LETTER OF MAP REVISION

SC 707 CULVERT REPLACEMENT

Community Name: Horry County, SC
Community Number: 450104
Flooding Source: Collins Creek

Prepared by:
Kimley-Horn and Associates

Exhibit 4. Topographic Work Map
Community Number: 450104
Community Name: Horry County, South Carolina
Flooding Source: Collins Creek
Project Identifier: SC 707 Culvert Replacement

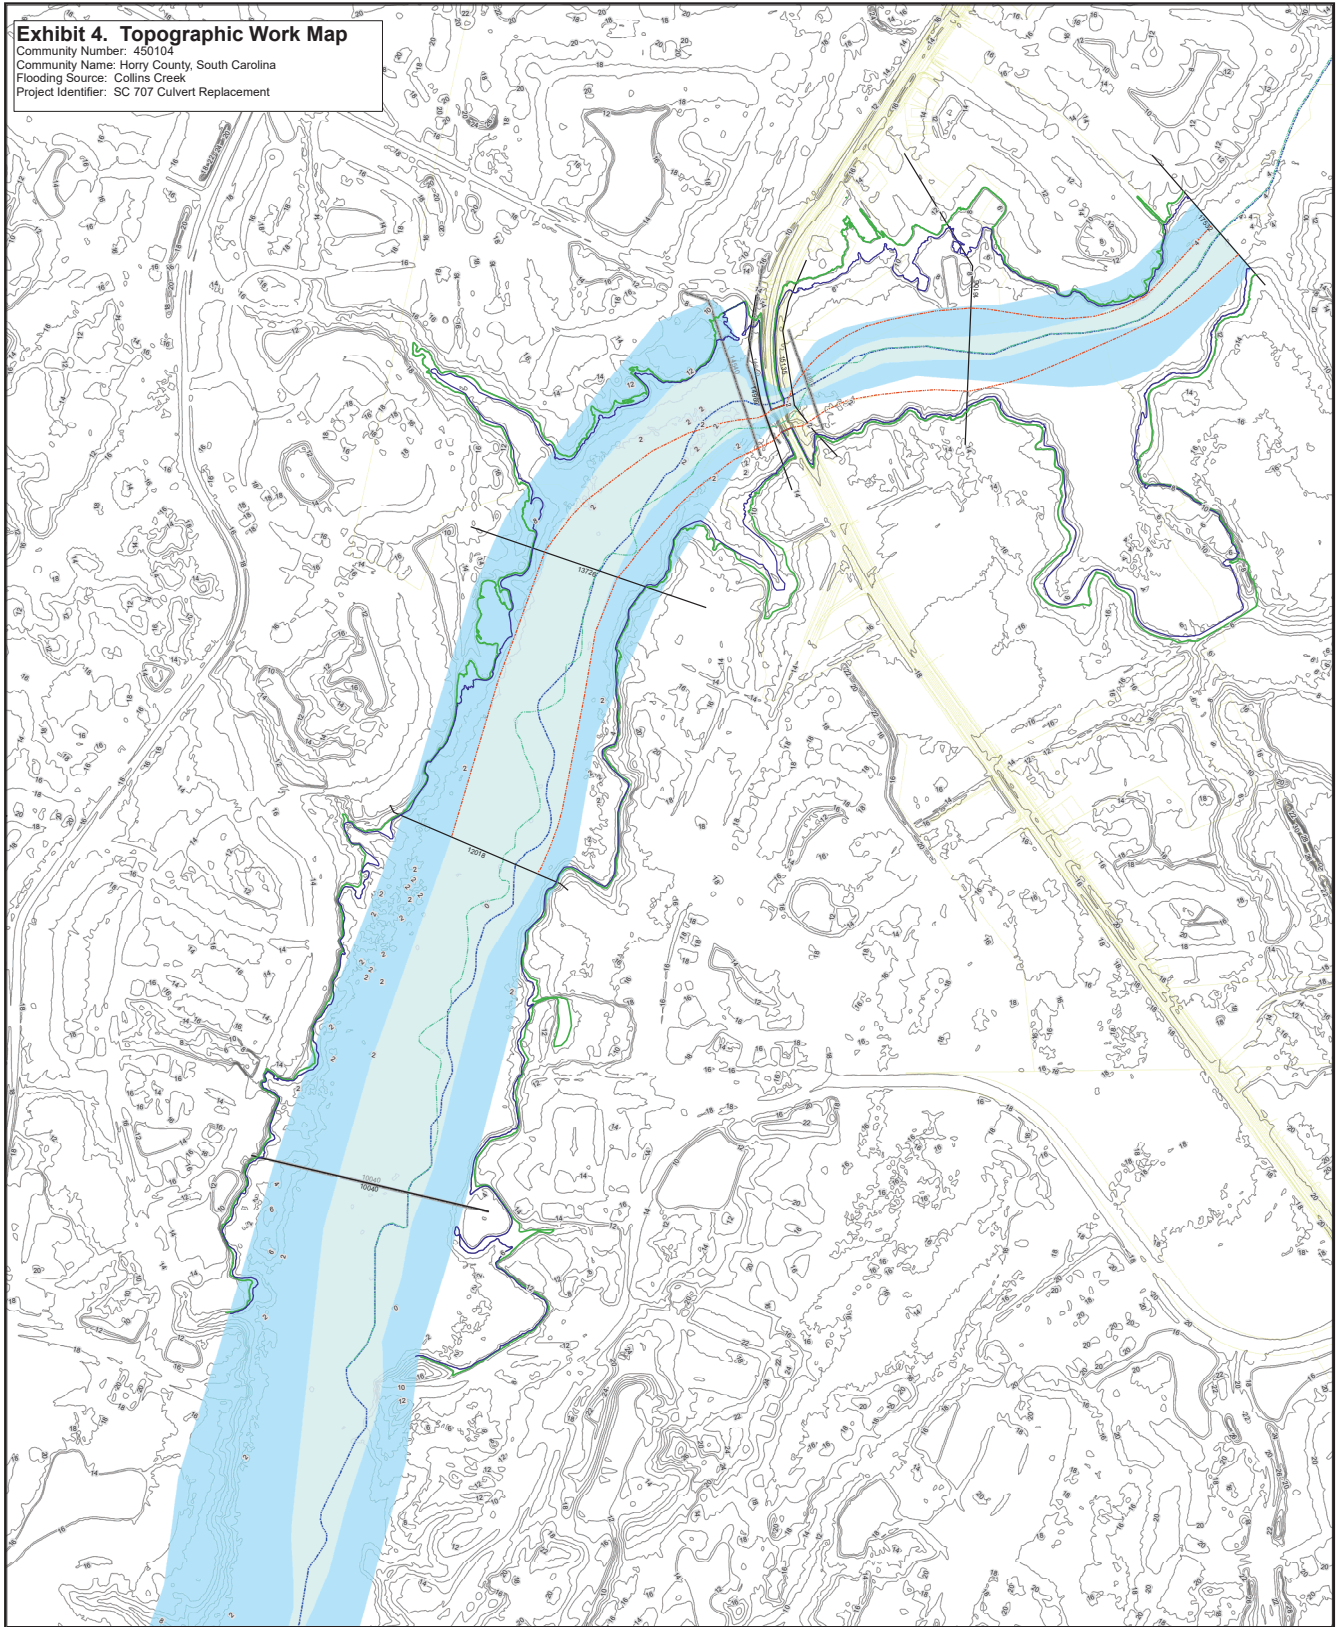
Comment 3: Based upon the above-referenced item 2, please submit a topographic work map, certified by a registered professional engineer, for the entire revision area that includes all applicable items listed on page 2, Section C, of MT-2 application/certification Form 2, entitled "Riverine Hydrology & Hydraulics Form," including the following information:

Response 3: *A revised topographic work map that incorporates the requested information is included with this submittal.*

EXHIBIT 6. ANNOTATED FIRM 45051C0731H

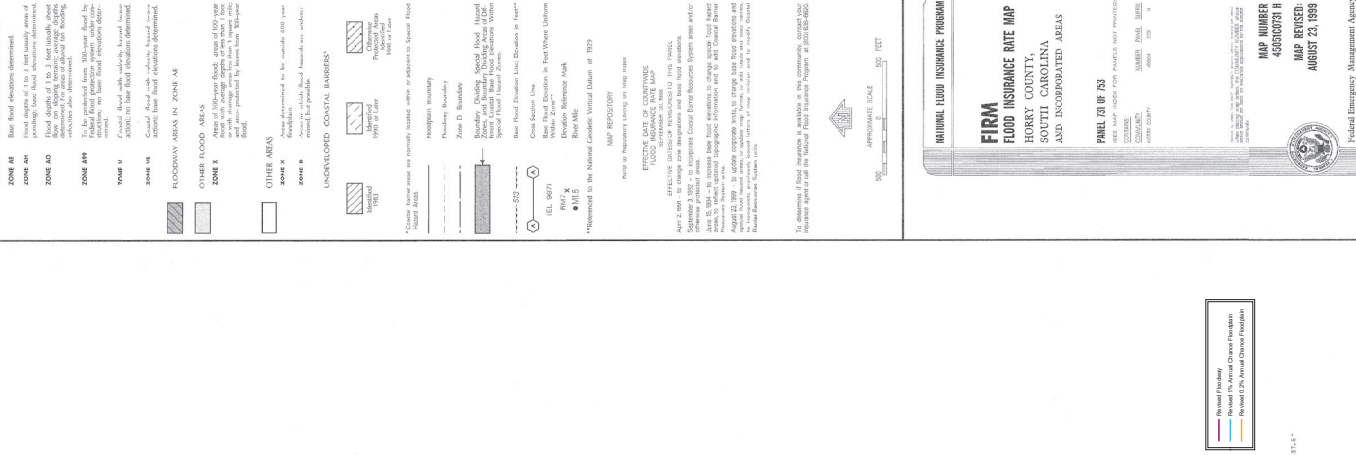
Comment 5: Based upon the above-referenced item 2, please submit a revised annotated Flood Insurance Rate Map (FIRM), at the scale of the effective FIRM, that shows the revised base floodplain, 0.2-percent-annual-chance floodplain, and regulatory floodway boundary delineations shown on the requested work map and how they tie into the boundary delineations shown on the effective FIRM at the downstream and upstream ends of the revised reach.

Response 5: *A revised annotated FIRM that incorporates the requested information is included with this submittal. Note: The FIRM panels that include the revised reach are based on different scales (one panel at 500-scale and one at 1000-scale), so the Annotated FIRM has been referenced to the larger scale.*

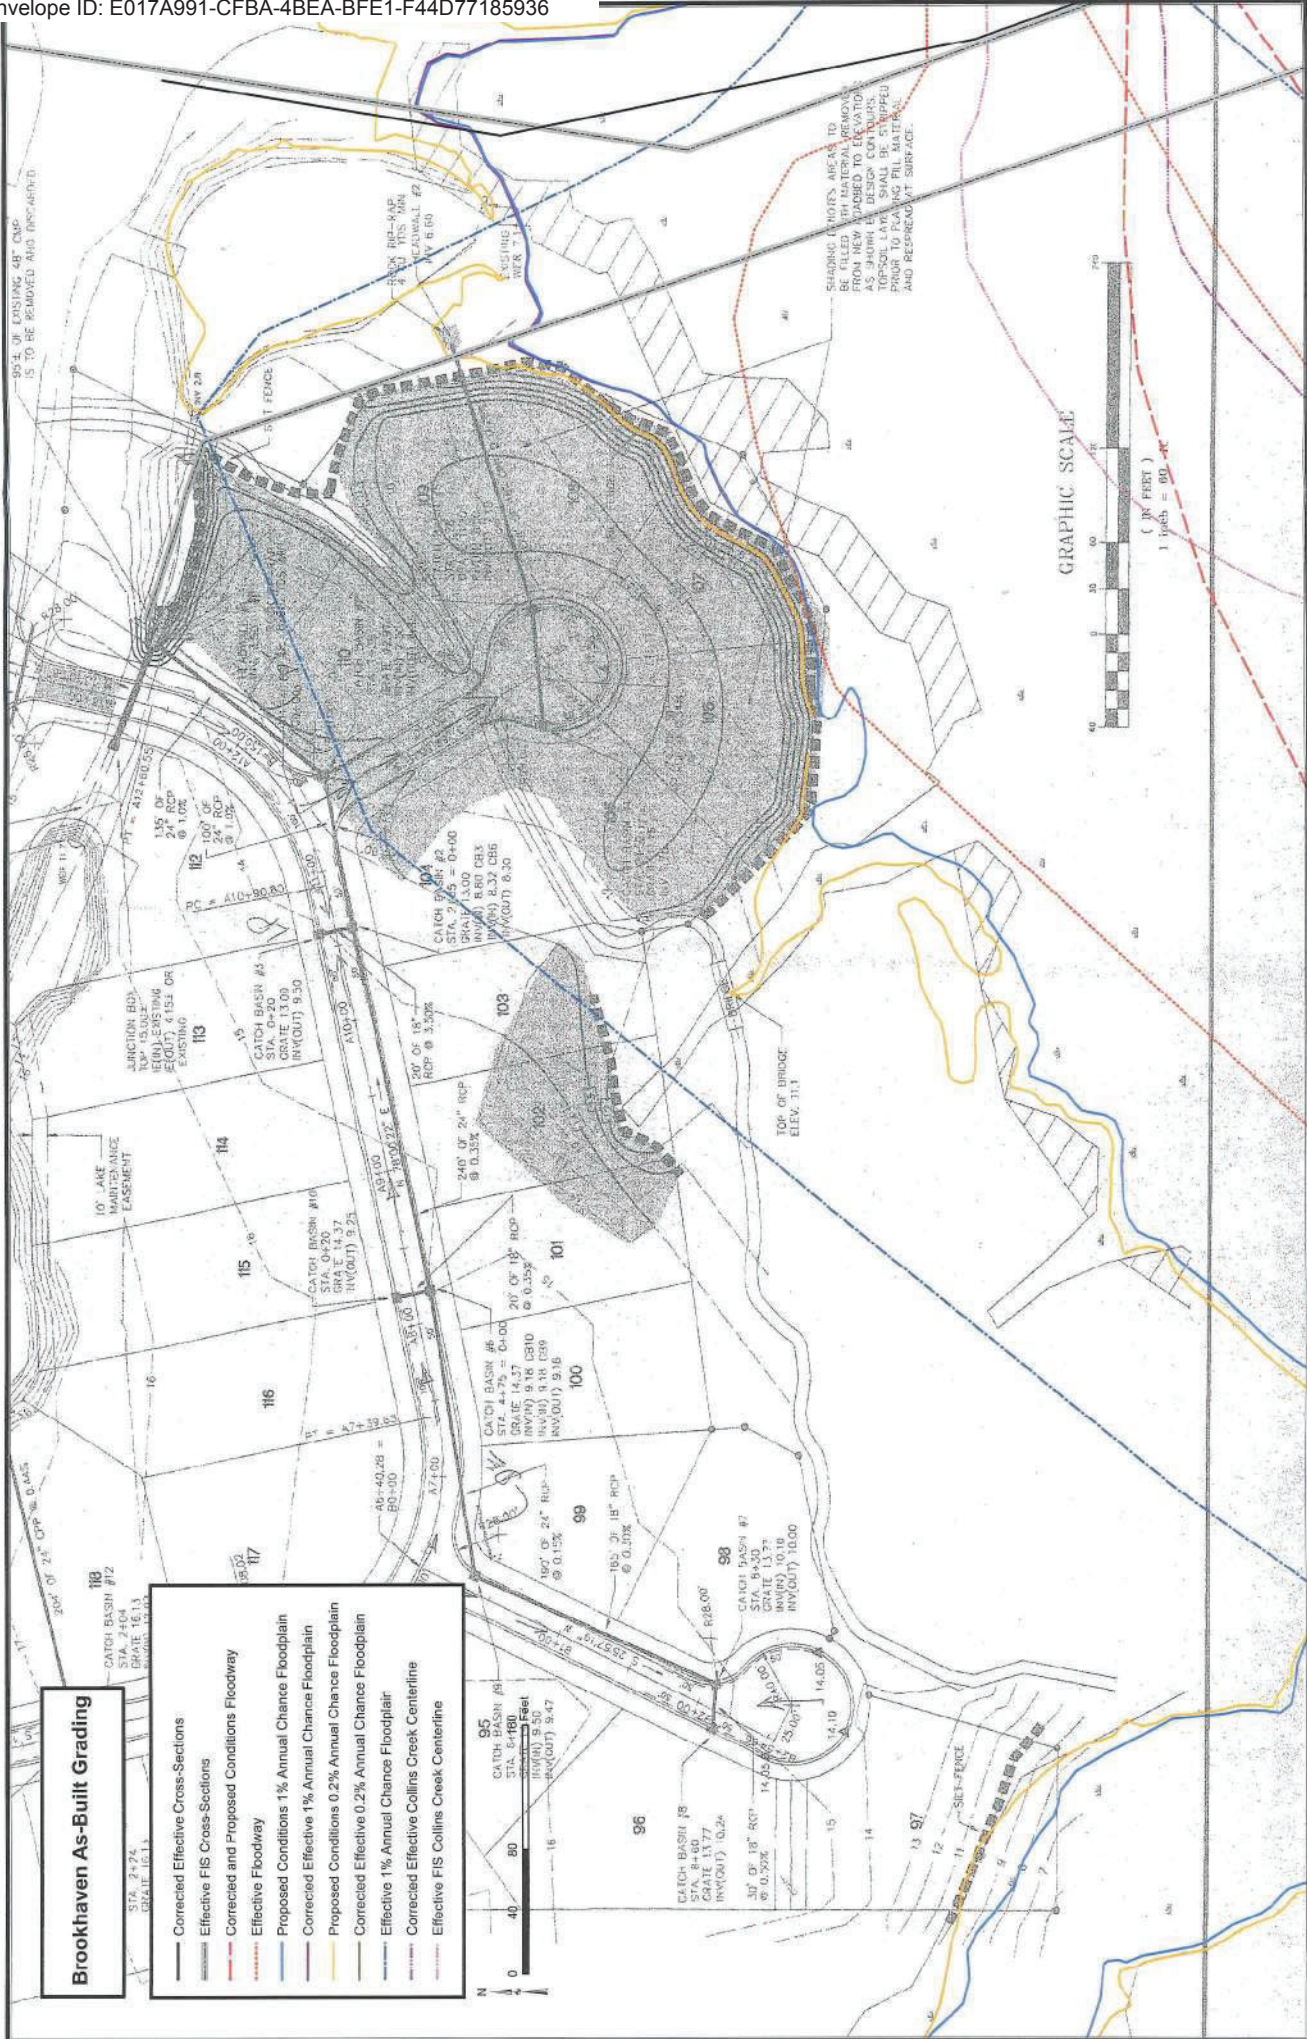
- Please show the topographic contour information used for the base floodplain and 0.2-percent-annual-chance floodplain boundary delineations along the entire revision area, from downstream to upstream limits of the revised area.

- Please make sure that floodplains boundary delineations along Collins Creek tributary take into account the backwater effect from Collins Creek.
 - On the submitted Exhibits entitled "Fox chase As-built Grading, Brookhaven As-built Grading, and CreekrIDGE Plantation As-built Grading," clearly show the topographic information, with labeled contour lines for the entire revision area. And please certify them.

3. The submitted topographic contour information is referenced in National Geodetic Vertical Datum of 1929 (NGVD) and the associated hydraulic model are referenced to the North American Vertical Datum of 1988 (NAVD)]. Please note that the information on the effective Flood Insurance Rate Map and in the Flood Insurance Study report are referenced to the National Geodetic Vertical Datum of 1929 (NGVD). Please make sure that the appropriate datum conversions are made before u made boundary delineations.

The topographic work map and annotated FIRM have been revised to include topographic contours (NAVD88) for the area of revision. The floodplain delineations represent the regulatory flood inundation levels for the 1- and 0.2-percent annual chance floods.

The vertical datum used for the hydraulic analysis and the mapping was NAVD88. This is noted on the topographic work map.
